# MEMO

Date: December 7, 2020

Re: Review for renovation with additions at 6199 Dublin Road

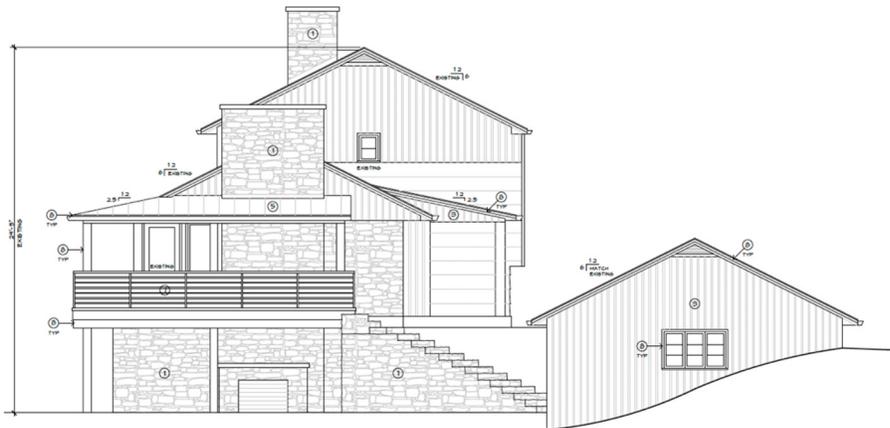
The new additions to the property consist of a one-story side-gable three-car garage partially covered by the hillside and a one-story side-gable master bedroom and bath addition to the north of the main house. The three-car garage has a standing seam metal roof and vertical board and batten siding to match the main house. It is not clear whether this siding matches the existing vertical siding by the large boxed bay window (preferable) or that under the eaves and gable of the second story of the main house. The one-story master bedroom addition has a side-gable asphalt shingle roof and wood frame walls covered with shingle siding and vertical board and batten siding, both similar to that of the main house. A small window resembling those in the second floor of the main house provides light to the master closet while patio doors with barn door shutters provide access to a patio. The master bedroom addition is attached to the main house by a one-story connector with vertical board and batten siding and a side-gable standing seam metal roof. Overall, the new additions are compatible with the main house and other buildings in the historic district in terms of style, scale, massing, and proportion. Materials selected—asphalt shingle roofing, standing seam roofing, vertical board and batten siding, and shingle siding—are appropriate and complement main house as well as other buildings in the district. However, certain design elements should be clarified or modified so the new additions do not detract from the character of the existing house or other buildings within the historic district. Areas that should be addressed include:

- Generally new additions should be to the rear of the main house. Consider moving the master bedroom addition behind the building line of the main house. If not possible, provide landscaping to lessen its visual impact from the street (this is shown in the rendering on the cover page, but not the site plan.)
